Access Compliance Report

(Curb Ramps)

Intersection ID: 14397	Main Street: BROOKHILL_RD	Cross Street: REMOUNT_RD	Location: E
ADA ID: EC2901656148	Ramp Type: PerpDiag	Initial Pass/Fail: Fail	Overall Compliance: No
		Severity Score: 12.5

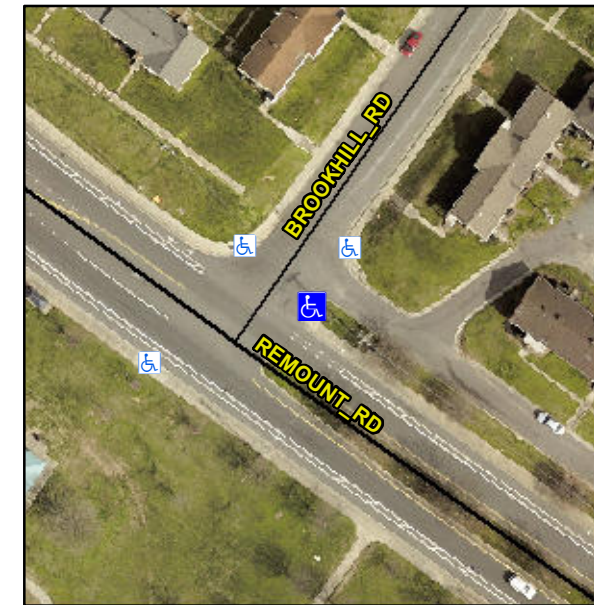
Not Found, R304.2.2

Compliance	Description	Data	Compliance	Description	Data
N/A	Ramp Length (in)	60.0	No	Ramp Slope (%)	9.6
Yes	Ramp Width (in)	48.0	Yes	Ramp XSlope (%)	0.1
N/A	Flare Type LT	N/A	N/A	Flare Type RT	N/A
N/A	Flare Slope LT (%)	N/A	N/A	Flare Slope RT (%)	N/A
N/A	Flare Traversable LT?	N/A	N/A	Flare Traversable RT?	N/A
N/A	Landing Length (in)	N/A	N/A	DWS Provided?	N/A
N/A	Landing Width (in)	N/A	N/A	DWS Contrast?	N/A
N/A	Landing Slope (%)	N/A	N/A	DWS Length (in)	N/A
N/A	Landing X Slope (%)	N/A	N/A	DWS Full Width?	N/A
N/A	Landing Curb? (Y/N)	N/A	N/A	DWS Offset (in)	N/A
N/A	Shared Landing?	N/A			
N/A	Gutter Ponding?	N/A	N/A	Gutter Slope (%)	N/A
N/A	Gutter Lip Ht (in)	N/A	N/A	Gutter X Slope (%)	N/A
N/A	Painted X Walk1?	No	N/A	Painted X Walk2?	No
	X Walk 1 Direction	To NW		X Walk 2 Direction	To SW
N/A	X Walk 1 Width (in)	N/A	N/A	X Walk 2 Width (in)	N/A
	X Walk 1 Slope (%)	3.1		X Walk 2 Slope (%)	2.9
	X Walk 1 X Slope (%)	0.5		X Walk 2 X Slope (%)	1.5

Remove & Replace Curb Ramp With Two New Directional Ramps or Equivalent.
